# Architectural Review and Historic Preservation Board Agenda Report

File: AR 19-24

RE: Architectural Review 19-24 (Creekside Place)  
Notre Dame Blvd., about 200 feet south of Humboldt Rd. APN 002-180-109

PRELIMINARY SITE PLAN / 1ST FLOOR PLAN

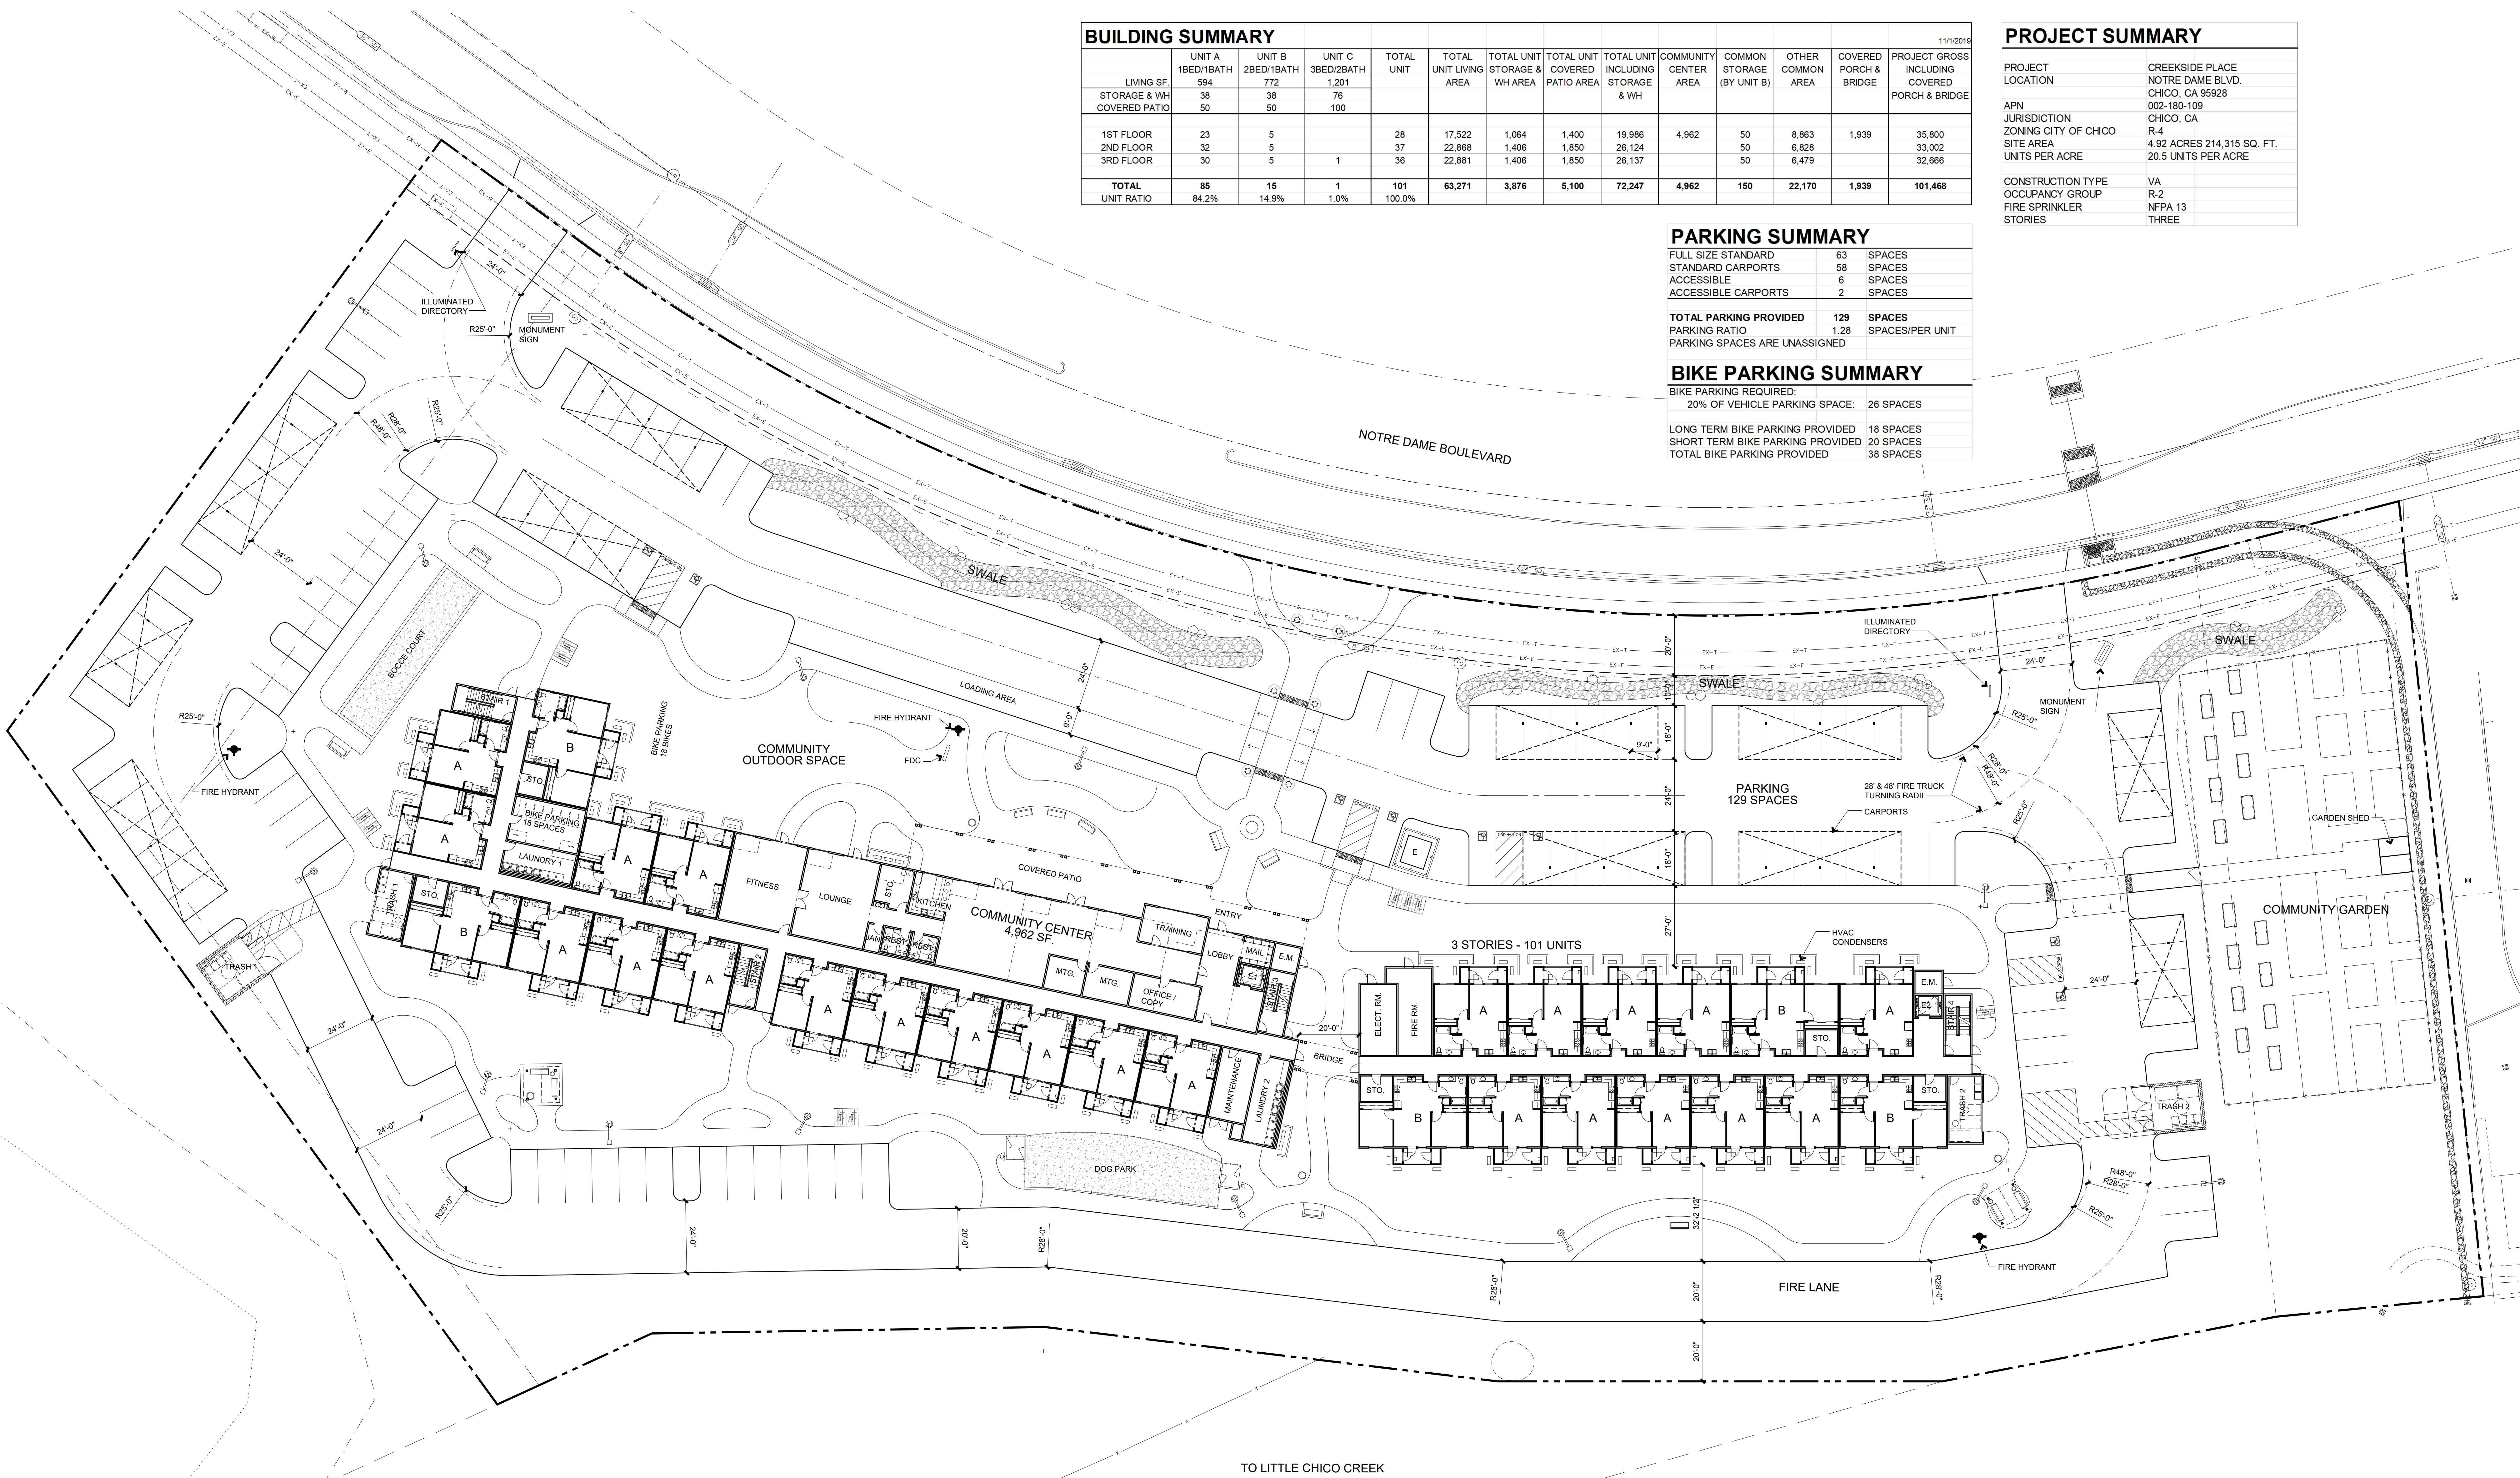
The site plan illustrates the layout and orientation of the buildings, as well as the location of the trash enclosure, site amenities, and parking (see **Attachment B**, Site Plan). The structure is centered on the property, and follows the general dogleg shape of the parcel. It is surrounded by sidewalks, parking areas, and landscaped areas, including a community garden.

The project includes a total of 129 off-street vehicle parking spaces in a partially-covered outdoor lot wrapping around the building, and bicycle parking in both indoor and outdoor locations.

Fifty off-street parking spaces are required based on the proposed land use. The project includes a total of 129 off-street parking spaces. Regarding excessive parking, Chico Municipal Code (CMC) Section 19.70.040.F states in part that "[P]arking spaces which exceed the minimum number of spaces required by more than 35 percent may be administratively approved by the Director when a combination of additional landscaping, pedestrian/bicycle improvements, and/or pervious surfaces are provided above those required by this chapter." In this case, the relocation and improvement of the existing Class I bike path and creation of a new bicycle crosswalk as required by Condition #7, along with the thorough landscaping and the decision to cover a large proportion of the spaces, meet the Code's requirements with regard to providing excessive parking. The Director administratively approved this arrangement on November 22, 2019 (see **Attachment I**).

The parking requirements of Chico Municipal Code Section 19.70.040 are met for this use. No guest parking is specifically required, but there will be adequate parking for guests and employees. Bicycle parking would be provided in a small number of dispersed carrells, accessible to entrances and exits. Indoor bicycle parking would be available to residents.

Parking lot lights would be dispersed around the building and mounted at 14 feet in height. The covered parking would also be illuminated underneath, and Condition #6 requires it to be constructed with minimal glare and spill in accordance with Chico Municipal Code Section 19.70.060.F and Figure 5-12. Mechanical units would be located primarily on the street side of the building, screened from view by appropriate fencing and landscaping. Two concrete block trash enclosures, covered as required, are proposed within the parking area, on either side of the building.

## PRELIMINARY LANDSCAPE SITE PLAN

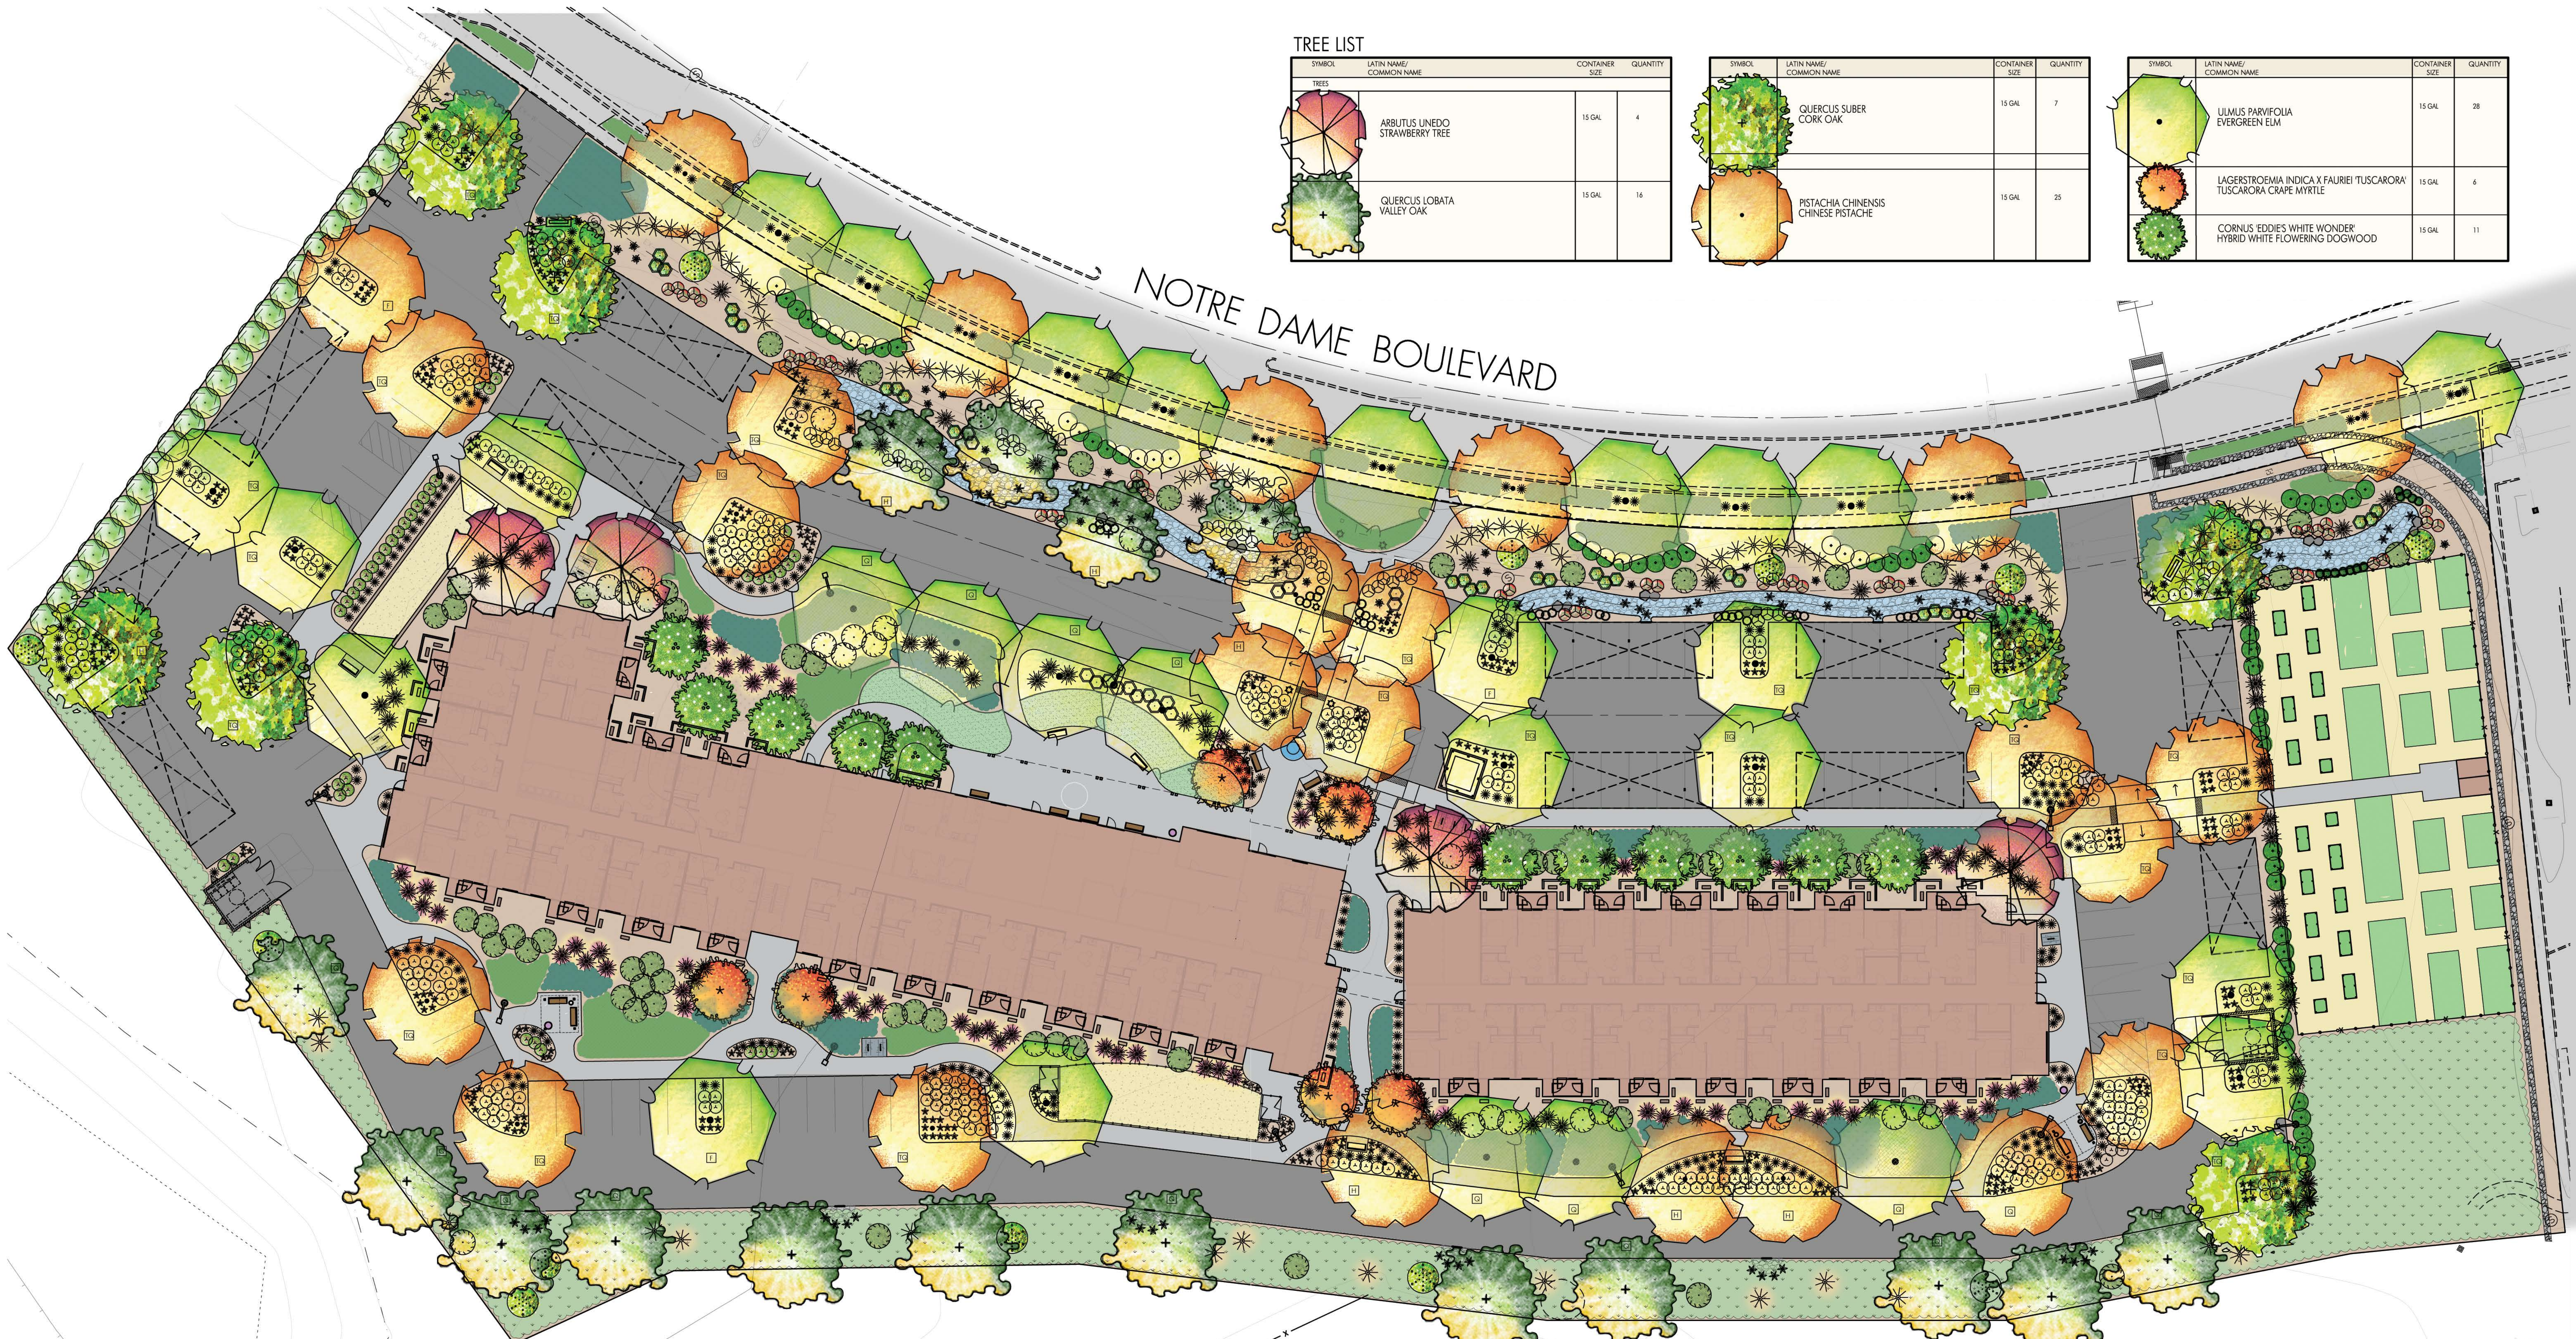
Removal of 16 trees is proposed (See **Attachment E**, Tree Removal Plan). The landscape plans call for a variety of species with low-to-moderate water demands (see **Attachment D**, Landscape Plan), with a large number of trees and bushes including Chinese elm and valley oak.

The landscape plans call for a variety of species with low-to-moderate water demands (see **Attachment D**, Landscape Plan), with a large number of trees and bushes. The primary

trees would be Chinese elm and Chinese pistache. Accents of valley oak, particularly on the creek side of the structure, will give a native feel, while cork oak and Madrid strawberry are proposed for variety. The trees, shrubs, and other plantings are located throughout the development, and street trees in particular will be of large and prominent species.

Landscape design includes a large number of trees and bushes. The parking lot will be well-treed, with the primary species proposed as Chinese elm and Chinese pistache. Accents of valley oak, particularly on the creek side of the structure, will give a native feel, while cork oak and Madrid strawberry are proposed for variety. The trees, shrubs, and other plantings are located throughout the development, and street trees in particular will be of large and prominent species.

Parking lot shading is more than adequate and a partially-shaded, shared recreational area will also contribute towards providing an attractive residential environment. Where specific screening and landscape elements are not yet explicitly delineated, Condition #5

4. All new electric, telephone, and other wiring conduits for utilities shall be placed underground in compliance with CMC 19.60.120.
5. Building plans shall delineate locations and detail as needed the final design of specific screening and landscape elements, subject to final approval by planning staff. This includes, but is not limited to, signs, irrigation equipment, and any changes to landscape planning that may be required due to alterations in configuration of the parking area of the property.

## TREE REMOVAL PLAN

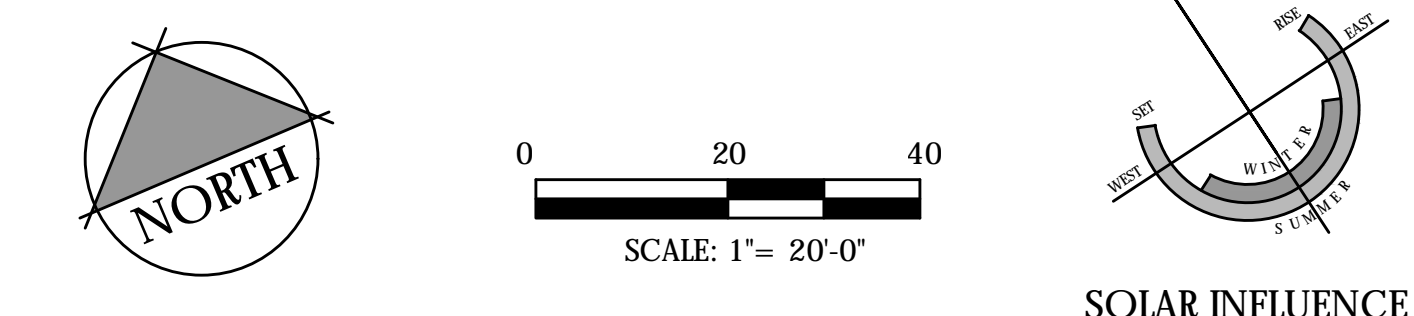
Removal of 16 trees is proposed (See **Attachment E**, Tree Removal Plan). Nine of those trees do not qualify for protection or mitigation under the City's ordinances, and one is already dead. It is obvious that many large trees have been removed in the past, as several stumps and large trunk pieces exist on the site. Condition #9 accounts for mitigation of the six trees proposed for removal which qualify, and for the preservation measures which must be taken around trees to remain.

9. As required by CMC 16.66, any trees removed shall be replaced as follows:
  - a. On-site. For every six inches DBH removed, a new 15-gallon tree shall be planted on-site. Replacement trees shall be of similar species, unless otherwise approved by the urban forest manager, and shall be placed in areas dedicated for tree plantings. New plantings' survival shall be ensured for three years after the date of planting and shall be verified by the applicant upon request by the director. If any replacement trees die or fail within the first three years of their planting, then the applicant shall pay an in-lieu fee as established by a fee schedule adopted by the City Council.

- e. All trees not approved for removal shall be preserved on and adjacent to the project site. A tree preservation plan, including fencing around drip lines and methods for excavation within the drip lines of protected trees to be preserved shall be prepared by the project developer pursuant to CMC 16.66.110 and 19.68.060 for review and approval by planning staff prior to any ground-disturbing activities.
